Welch Allyn, Inc. 4341 State Street Road Skaneateles Falls, NY 13153 USA	<b>URGENT: Field Safety Notice</b>	2021-07-001-MKE-005
---	------------------------------------	---------------------

ELI280, MLBUR280 and BUR280 Electrocardiographs

ELI280 resting electrocardiograph - Patient mismatch/Software Upgrade

**FSCA-identifier:** 2021-07-001-MKE-005

Figure.1

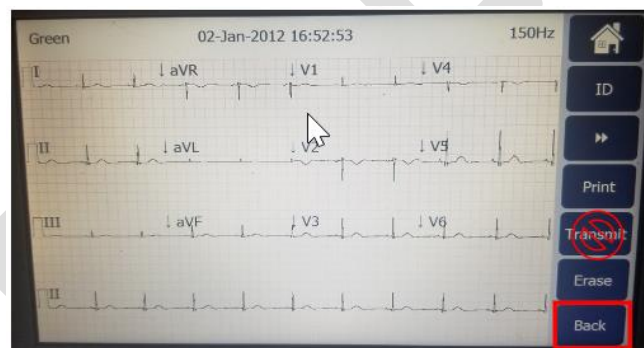
1. An ECG is acquired for Patient A and stored to the cardiograph.
2. An ECG is acquired for Patient B and stored to the cardiograph.
3. The ECG record associated with Patient A is retrieved from memory and any Patient Demographic information is edited.
4. After editing, the "Resting ECG" screen is presented as shown below. Figure 1
5. Pressing the TRANSMIT button from this screen (following any Patient Demographic edit) will transmit an ECG record other than for patient A. (see figure 2, which shows the Resting ECG screen).

If an ECG record is retrieved from the patient directory for a Patient Demographic edit to be performed, once the information has been edited and the screen above (Fig 1) is presented, do not press the transmit button. Instead, press the BACK button which will SAVE the changes to memory and present the user with the following screen, where the SYNC button can be used to transmit the desired record to the configured destination.

Figure.3

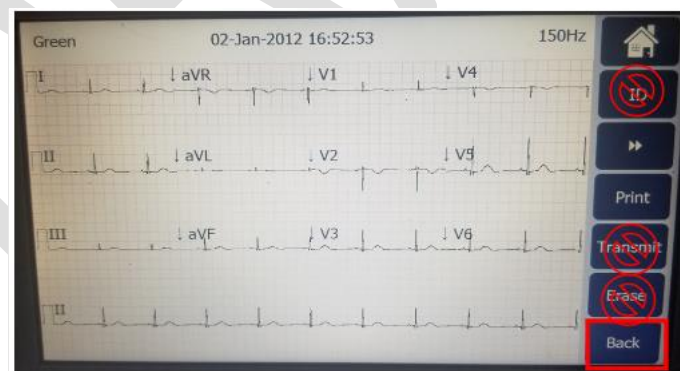
1. An ECG is acquired for Patient A and stored to the cardiograph.
2. An ECG is acquired for Patient B and stored to the cardiograph.
3. The ECG record associated with Patient A is retrieved from memory and ID information is edited.
4. After editing, the “Resting ECG” screen is presented as shown in Figure 3.
5. The user decides to make another ID Edit without leaving the “Resting ECG” screen and presses the “ID” button - Figure 3.

6. After the second edit is performed, the “Resting ECG” screen is once again presented as shown above.
7. Pressing the TRANSMIT button from this screen (following two ID edits in a row as defined above) will transmit an ECG record with the patient demographics

from Patient A and the ECG record for Patient B, this “hybrid” record is then stored in the cardiograph as second record with patient A demographics, and Patient B will no longer be listed in the directory.
